Product Update Bulletin # 6440

Valve Communication and Control

All Axiom AX models

Design Change Notification

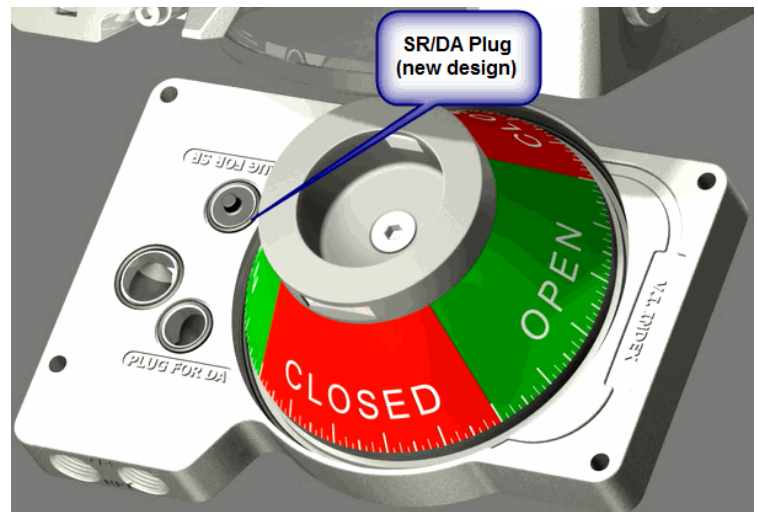
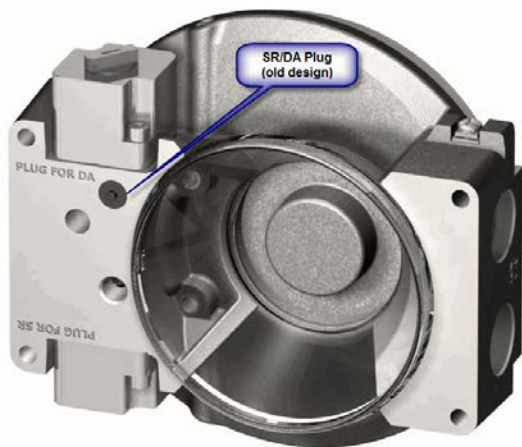
In preparation for the launch of a higher flow rate solenoid valve option for the Axiom AX platform later this year, we have made a design change to the SR/DA selection plug configuration.

The Axiom AX was initially designed with the SR/DA plug installed and included with the Axiom housing. We have changed the design and will be shipping the plug installed in the mounting/manifold plate as shown below.

If you find during installation that you have a plug in both the Axiom unit and the manifold mounting plate, just remove the plug from the Axiom unit, it is not needed.
